**ITEM 32. TRAFFIC TREATMENT – INTERSECTION UPGRADE – MENTMORE
AVENUE AND QUEEN STREET ROSEBERY**

TRIM RECORD NO: 2015/529526

MENTMORE AVENUE & QUEEN STREET, ROSEBERY

Traffic Treatment – Intersection Upgrade – Mentmore Avenue and Queen Street Rosebery

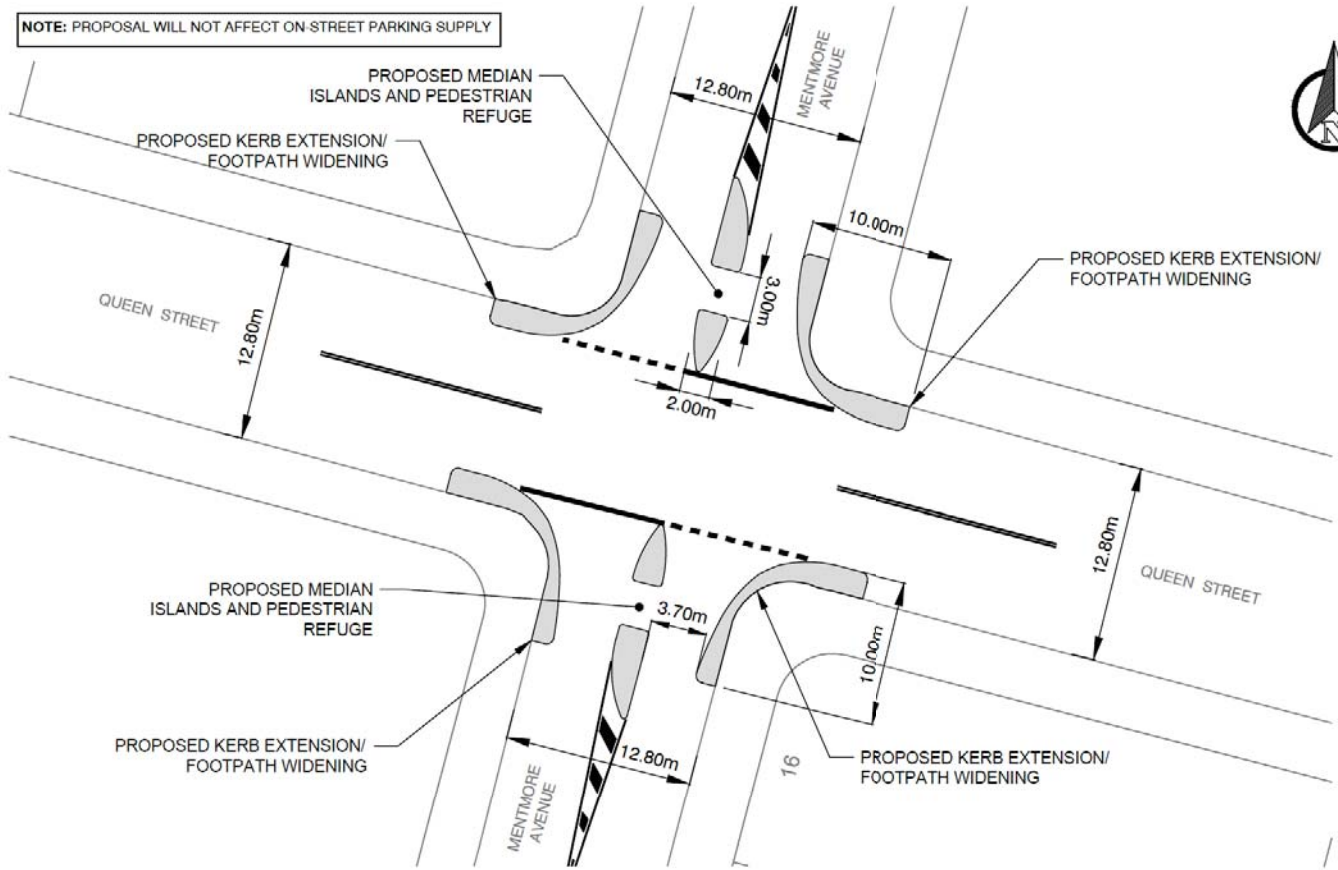
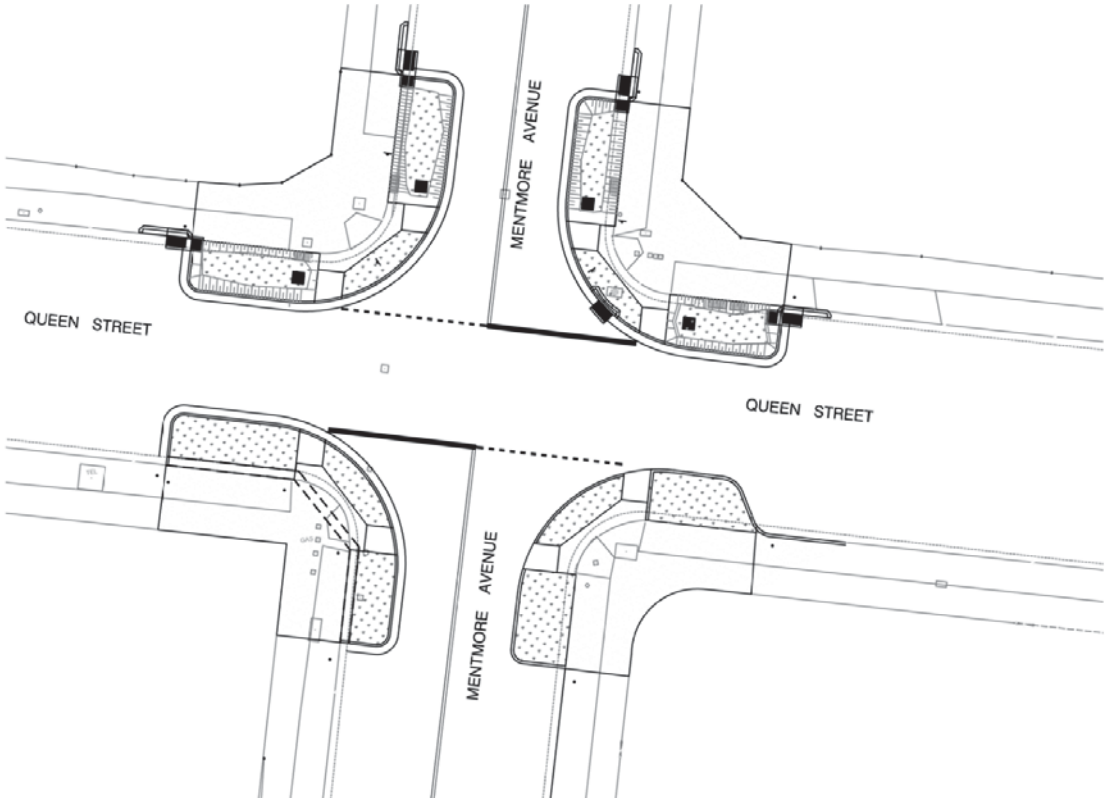
It is recommended that the Committee endorse the following design changes to the treatments proposed at the intersection of Mentmore Avenue and Queen Street, Rosebery:

- (A) Widen footpath extensions on all four corners of the intersection; and
- (B) Removal of both central medians in Mentmore Avenue, north and south of Queen Street.

Following a review at the detailed design stage, the proposal has been updated to include widening of kerb extensions on all four corners of the intersection. The proposed widening will include the removal of the median islands proposed previously in Mentmore Avenue, north and south of Queen Street.

The revised proposal is consistent with existing treatments for intersections in Rosebery and will enhance safety by narrowing lane widths and turning radius to reduce vehicle speeds approaching the intersection.
